P5020A-03B-S

Safety Service Note

P5020A Keysight Streamline USB Vector Network Analyzer

“POTENTIAL BURN INJURY (HIGH TEMPERATURE) HAZARD”

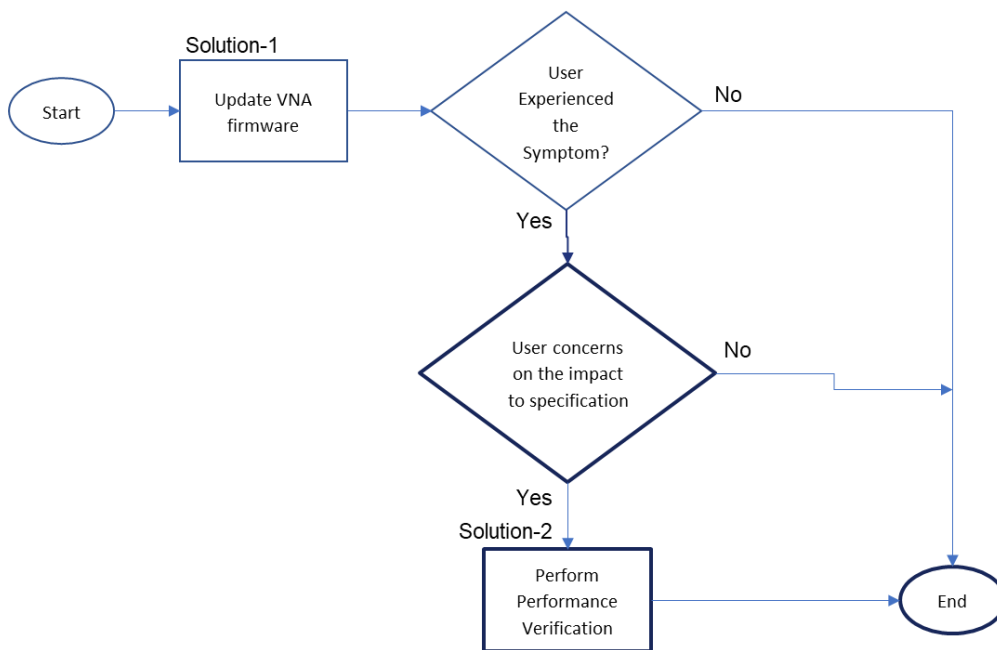
VNA fails to start with the following symptoms.

- 1. LED indicator (below circle) turns red.
- 2. cooling fan does not work
- 3. If user leaves the VNA with this LED indicator red without turning off power switch, it continues to overheat and becomes too hot.

Solution-1: Update VNA firmware by user

Action-1: Updating the firmware eliminates this potential risk of overheating.

1. **Install the latest VNA firmware Rev. A.15.40.13 or newer** on users' controller PC(s).
The latest firmware enhanced the thermal fan control mechanism.
2. Once the latest firmware is installed, proceed with the restart of both **controller PC** and **VNA**.
3. Launch the VNA firmware. Ensure VNA powers up and launches into firmware correctly after firmware update is done.
